City of Portland, Maine - Building or Use Permit Application 389 Congress Street, 04101, Tel: (207) 874-8703, FAX: 874-8716 Phone: Permit No: Owner: Location of Construction: akk 93 Coer Ridder Phone: BusinessName: Lessee/Buyer's Name: Owner Address: Permit Issued: Phone: Address: Contractor Name: PERMIT FEE: COST OF WORK: Proposed Use: Past Use: Single family Same INSPECTION: Deck FIRE DEPT. □ Approved Use Group: 8-3 Type 53 ☐ Denied CBL: Signature: Zoning Approval: PEDESTRIAN ACTIVITIES DISTRICTARA.D.) Proposed Project Description: Approved Action: Special Zone or Reviews: Approved with Conditions: ☐ Shoreland 12 x 16 slider w/deck Denied □ Wetland ☐ Flood Zone □ Subdivision Date: Signature: ☐ Site Plan mai ☐minor ☐mm ☐ Date Applied For: Permit Taken By: July 11, 2000 Gavle Zoning Appeal □ Variance This permit application does not preclude the Applicant(s) from meeting applicable State and Federal rules. ☐ Miscellaneous Building permits do not include plumbing, septic or electrical work. ☐ Conditional Use 2. ☐ Interpretation Building permits are void if work is not started within six (6) months of the date of issuance. False informa-3. ☐ Approved tion may invalidate a building pe

Deck Plan 1404

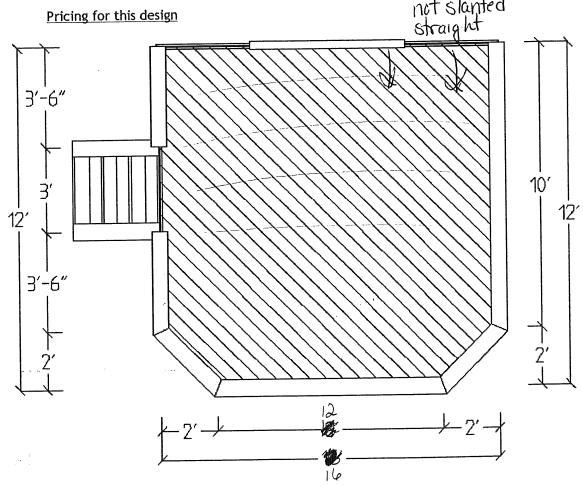
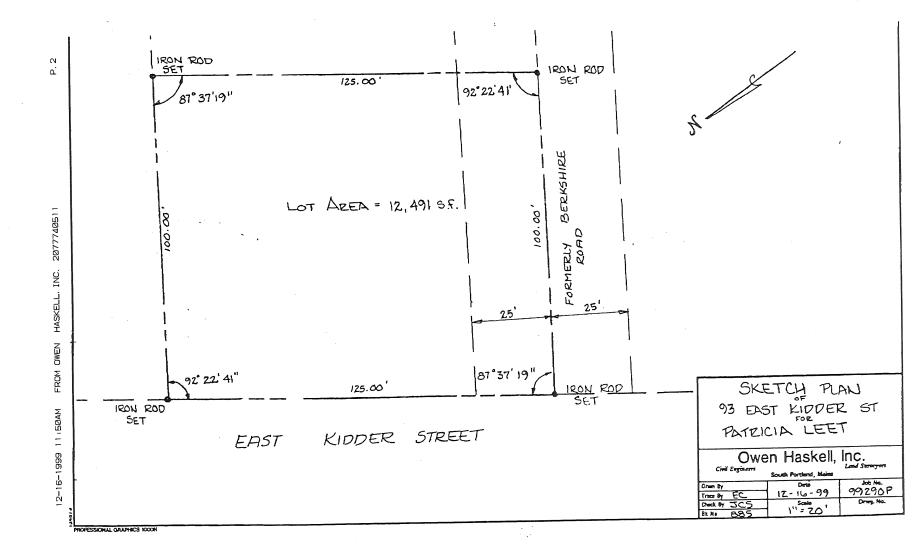
X11. Guardrails & Handrails: A guardrail system is a system of building components located near the open sides of elevated walking surfaces for the purpose of minimizing the possibility of an accidental fall from the walking surface to the lower level. Minimum height all Use Groups 42". In occupancies in Use Group A,B.H-4, I-1, I-2, M and R and public garages and open parking structures, open guards shall have balusters or be of solid material such that a sphere with a diameter of 4" cannot pass through any opening. Guards shall not have an ornamental pattern that would provide a ladder effect. (Handrails shall be a minimum of 34" but not more than 38". Exception: Handrails that form part of a guard shall have a height not less than than 36" and not more than 42". Handrail grip size shall have a circular cross section with an outside diameter of at least 1 1/2" and not greater than 2". (Sections 1021 & 1022.0). Handrails shall be on both sides of stairway. (Section 1014.7)

32. Boring, cutting and notching shall be done in accordance with Sections 2305.3, 2305.3.1, 2305.4.4 and 2305.5.1 of the City's Building Code. 33. Bridging shall comply with Section 2305.16. 34. Glass and glazing shall meet the requirements of Chapter 24 of the building code. (Safety Glazing Section 2406.0) All signage, shall be done in accordance with Section 3102.0 signs of the City's Building Code, (The BOCA National Building Code/1999). Find allached requirements For STAILS, ghandr
